Bulletin

MODEL: BENTLEY MARK VI

MODIFICATION.

REAR BRAKE EQUALISER.

FIG.4.

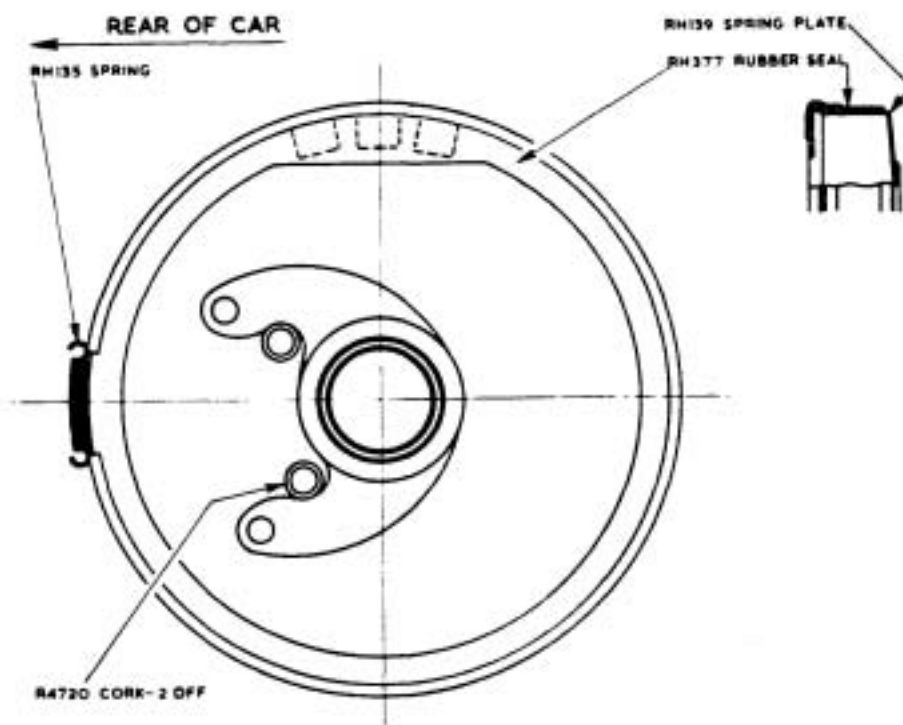
Whenever a servo is overhauled following a complaint of inefficiency which is found due to oil or water contamination of the liner and when there is no obvious source of leakage such as from the servo main shaft seal, the engine or chassis lubrication systems, or water leakage from the cooling system, the servo is to be completely sealed with the special rubber seal RH.377.

The servo spring plate, lined plate, pressure plate and servo main shaft are to be put together so that after the seal has been fitted the servo can be completely re-assembled and re-fitted, (Fig.4).

With the pressure plate uppermost, the rubber seal is placed on top with the flap covering the ventilating slots. The rubber seal is then placed right over the rim edge at the ventilating slots and without stretching, held there, then the opposite side is to be eased right over

the edge of the plate, not by pulling on the outer edge of the seal as might be expected, but by pulling on the inner diameter; this prevents distortion of the outer periphery. The rest of the seal is then eased into position, still pulling on the inside diameter until the inner periphery fits closely into the spigot running around the upper face of the pressure plate. The whole seal is then to be eased into position finally and retained by the protector ring which must be fitted with the lower rate spring RH.135, otherwise it will not fit over both the seal and the pressure plate. The spring is to be positioned towards the rear of the car and not to the lowermost position as was usual. On certain servos the ends of the brake actuating lever operating pins will be open; these must be sealed with two corks (Fig.4).

Fig.2. Section-Return valve assy.
master cylinder.

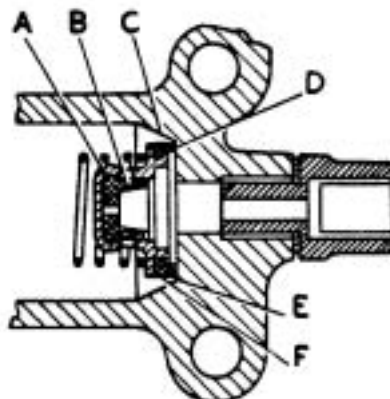
There have also been cases of ingress of air into the system due to non-sealing of the rubber valve washer 'F' Fig.2. against the face 'D' at the outlet end of the cylinder. The sealing lip 'A' Fig.1. of the rubber cups in the front brake expanders is normally held in firm contact against the bore of the expander by a residual hydraulic pressure of about 12-14 lbs. per sq. in. created by the spring loading of the return valve illustrated in Fig.2. Should this valve fail to maintain the hydraulic pressure, air may enter past the cups of the expanders owing to the comparatively low pressure exerted by the cups themselves against the bore.

Examination revealed that the primary cause of the valve washer 'F' not seating correctly, was due to the diameter of the face 'D' of the master cylinder being too small, causing the valve washer to make heavy contact with the rough un-machined tapered sides 'C' of the cylinder resulting in excessive wear and distortion of the valve washer.

- (i) Fit a new rubber washer 'F' (RG-7043) and a rubber cup 'B' (CD-130) to the valve body 'A'. Place the coil spring on to the valve and enter into the cylinder and check that the valve assembly has a diametrical movement of approximately 0.020" (0.50 mm) to ensure that there is sufficient clearance between the outer diameter of the valve washer at point 'E' and the cylinder.

FIG. 1.

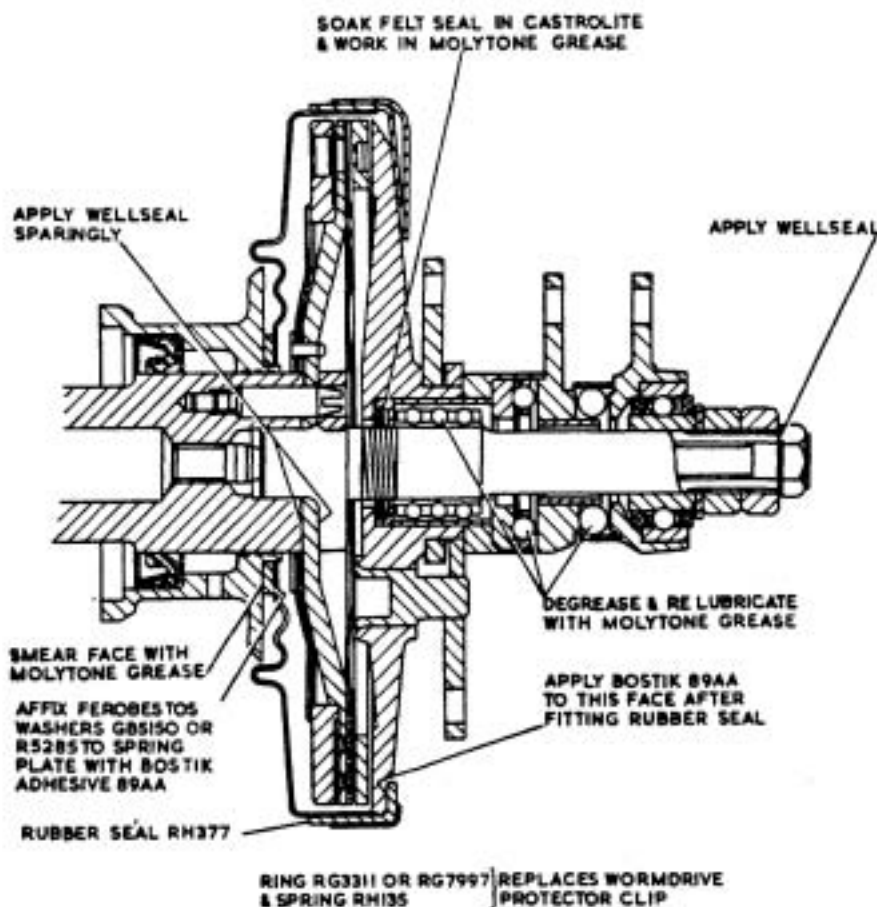
In order to ensure the fullest possible life, the servo motor sealing has been improved on production cars. Existing cars should be modified and brought to this standard, whenever a servo is dismantled.

Before re-assembling, the following modifications are required, if not already incorporated.

1. Remove the water drain on the servo spring plate, this is simply done by unsweating.

Blank off the spring plate drain holes located in the rim, by filling with solder. This is best done by tinning the inside of the rim, resting the spring plate holes downwards on a sheet of asbestos, so that solder is prevented from running through and building up on the outside of the rim. The solder is then smoothed over and the spring plate repainted with a high quality air drying chassis black.
